**Re: Response to DEQ's Comments on Exhibit C Scope of Work Measures (in letter from DEQ to undersigned dated October 9, 2024)
M Carter Commons (MCC) Development
Cleanup Project ID No. 6702**

SUBJECT: Revised PPA Consent Order, Exhibit C Scope of Work Measures Soil and Soil Gas Sampling Within a Former Landfill at the M. Carter Commons Senior Housing Development, 3715-3717 N Interstate Avenue, Portland, Oregon 97217

Figure 1. Property Map with Soil Gas Monitoring Well & Soil Characterization Boring Locations.

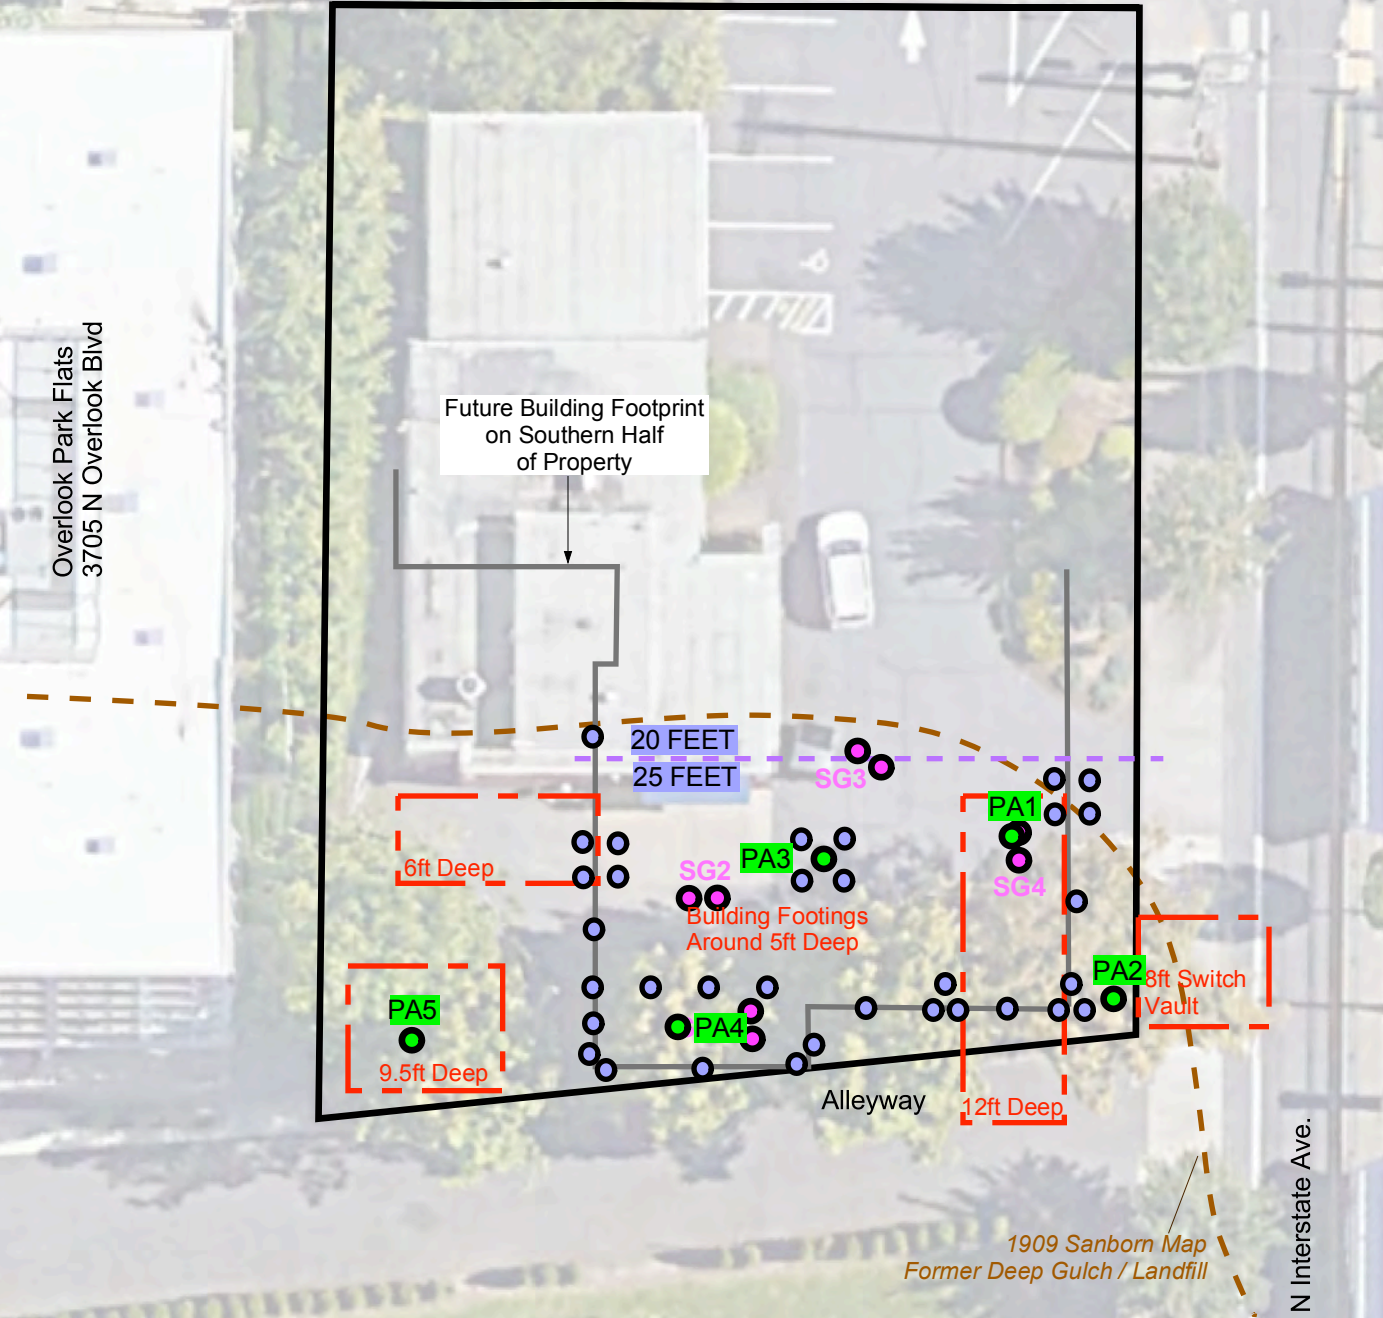
- a. DEQ recommends methane measurements at depths consistent with both 5 and 10 feet below the anticipated future foundation floor slab.

8 soil gas monitoring wells were installed at 4 locations, with one well at 5 feet and one well at 10 feet below the future slab at each location. The slab elevations were determined by review of the MCC Grading Plan, Sheet C200. The 5-foot soil gas well screens were installed to adjusted depths ranging between approximately 5.42 feet and 6.92 feet below ground surface (bgs). The 10-foot soil gas well screens were installed between approximately 10.42 feet and 11.92 feet bgs.

The Work Plan will be revised to include the soil gas monitoring wells installation information above and an updated site map.
